# DENFORD MACHINE TOOLS.

## NOTICE OF MODIFICATION TO MANUFACTURED PART.

ML.115/923.

GEAR BOX - SLIDING DOG SHAFT.

ML.115/923

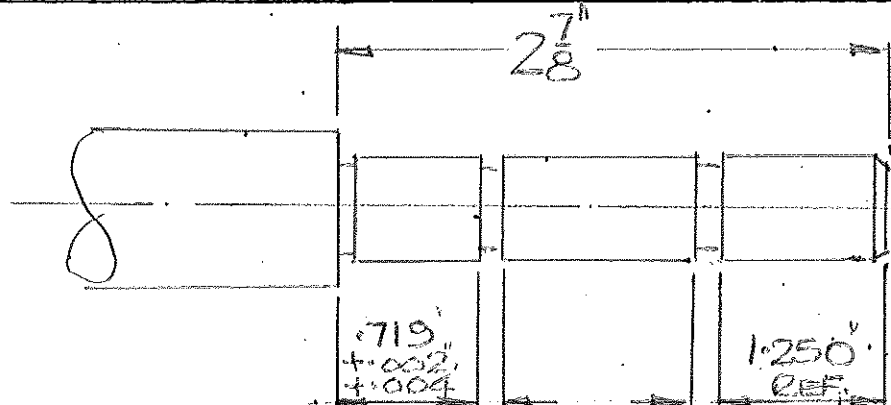
TO REPLACE THE 'E' CLIP REF. 1500-396 E WITH A COLLAR. IF EXCESS PRESSURE IS APPLIED TO THE CHANGE LEVER, THE 'E' CLIP CAN BE DISLODGED.

C'CLIP GROOVES: .046-.000  
WIDE \$ .396 +.003  
DIA.

THESE TWO C'CLIP GROOVES ARE NOW OBSOLETE, THE ONE ON THE RIGHT HAS NOT BEEN USED FOR SOME YEARS.

THE GEAR ML.115/930 IS NOW HELD IN POSITION WITH A COLLAR, ML.115/1005 SH.5008/31 (AN OBSOLETE PART) HAS BEEN RE NUMBERED AS ML.115/1005.
